Global Change Notification (GCN)

Product Family

Series

Before and after the rib change

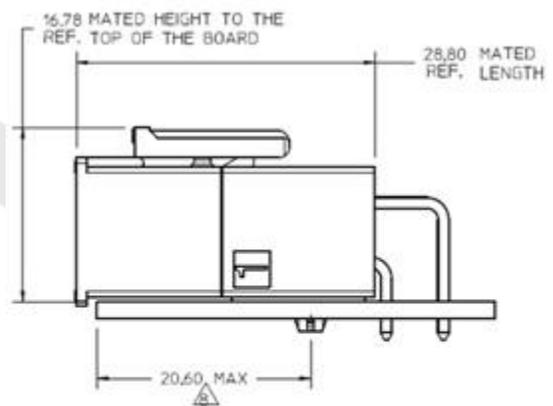
Change Description

⚠ TO AVOID INTERFERENCE BETWEEN RECEPTACLE AND PCB, HEADER MUST BE PLACED WITHIN 20,6 MAX FROM EDGE OF PCB AS SHOWN FOR 4 THRU 12 CKTS, FOR 2CKT PARTS THIS DIMENSION IS 15,1 MAX.
